Technical Service Information

CHRYSLER A470 SERIES REVERSE BAND STRUT BREAKAGE

Figure 1

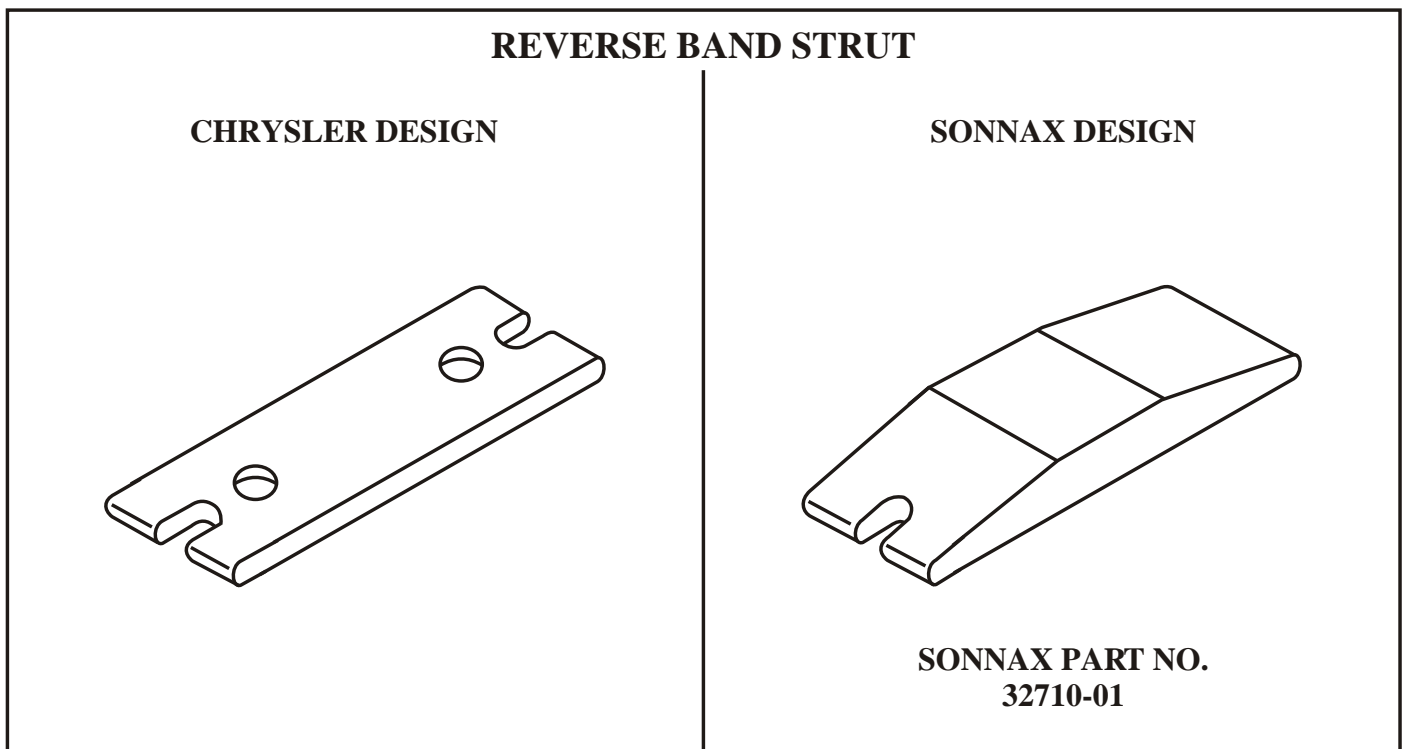
COMPLAINT: Some vehicles equipped with the Chrysler A404, A413, A470, A670 front wheel drive transaxle, may exhibit a no reverse condition before and/or after rebuild.

CAUSE: The cause may be, a bent or broken reverse band strut (See Figure 1).

CORRECTION: There is now a new design reverse band strut available from Aftermarket Suppliers for the Chrysler A404 Series transaxle, that has a thicker cross-section in the middle to provide much greater resistance to bending, and is manufactured out of a high quality hardened alloy steel that has a much higher yield strength than the original equipment material. This new design reverse band strut is manufactured by Sonnax, and is available under Sonnax part number 32710-01 (See Figure 1).
